TITLE: 700RB-II PREAMP

REV. A

PART NO: 206-0251-A
 COMPANY: GALLIEN-KRUEGER
 FILENAME: 6251A

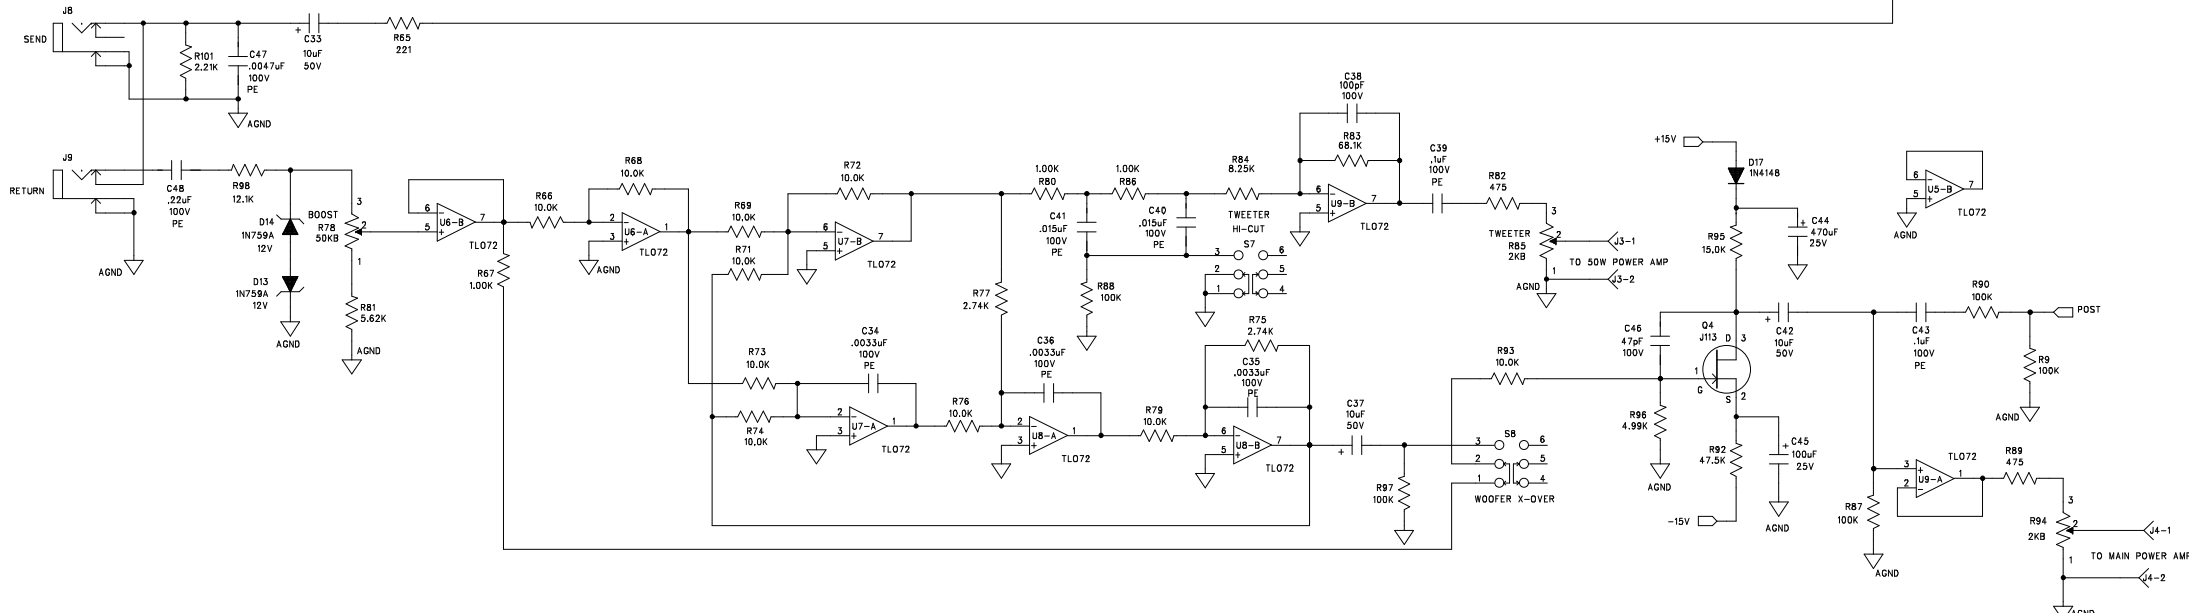
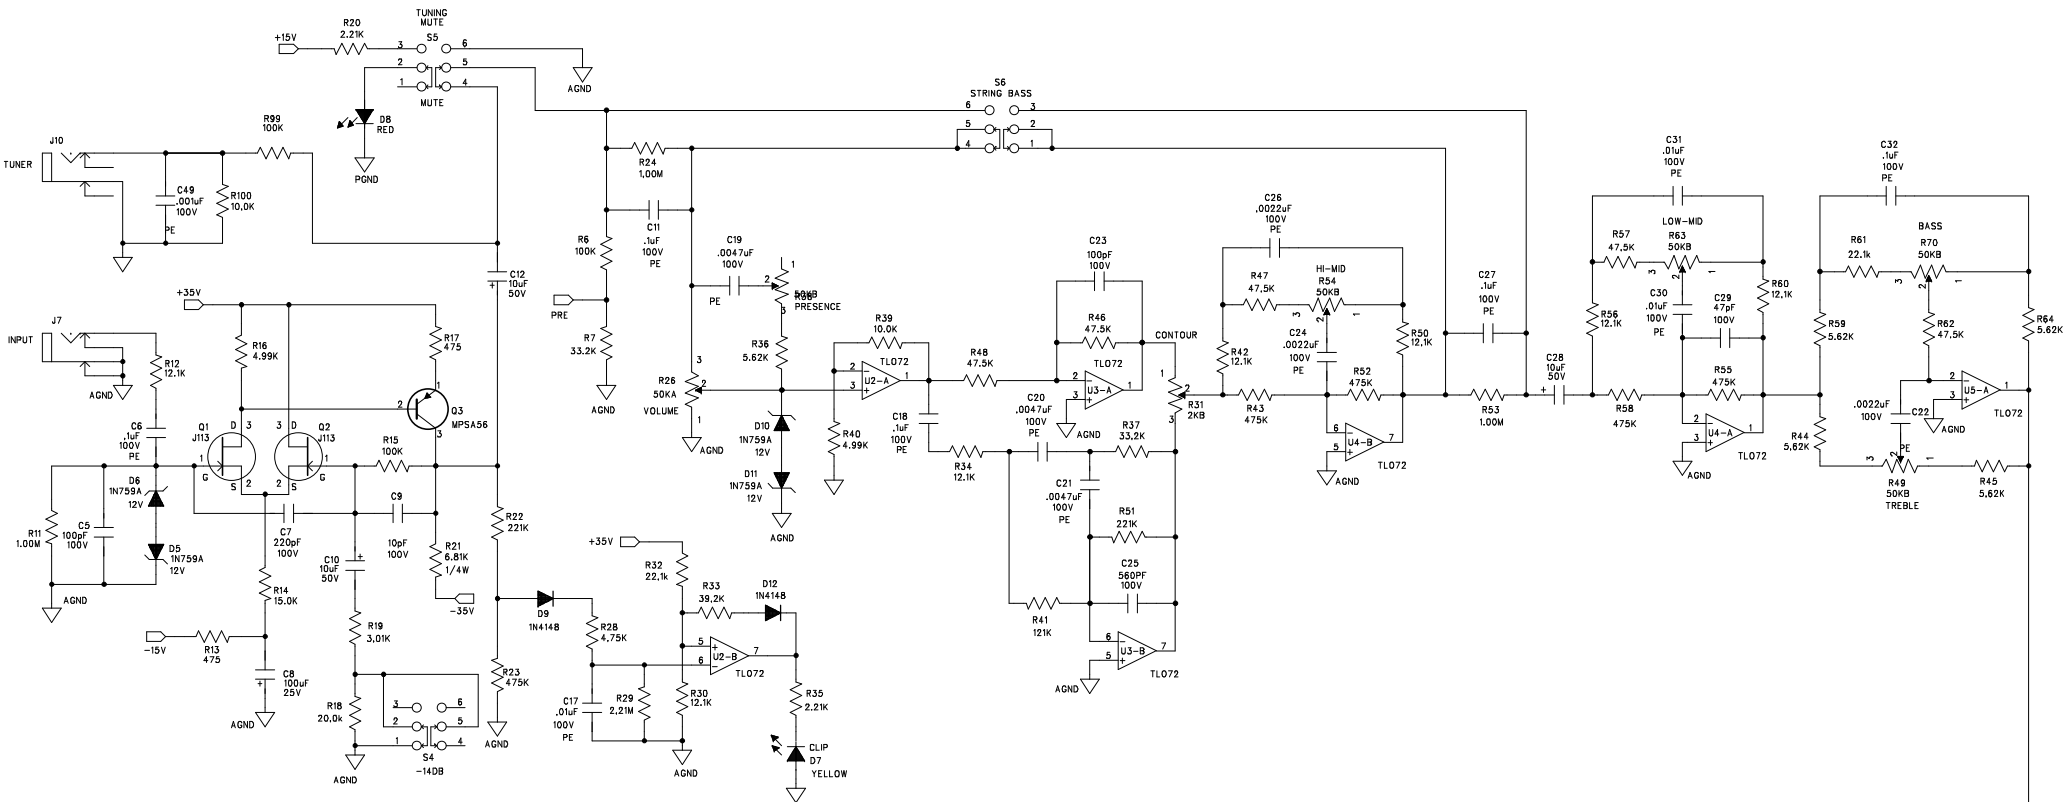
NOTES:
 1. CHANGE BOARD NO. TO 206-0251-A FROM 206-0105-02.
 2. CHANGE R18 TO 20.0K FROM 15.0K.
 3. CORRECT SHORTED TRACE FROM C45 TO S8.
 4. UPDATE HOLE AND PAD SIZES.
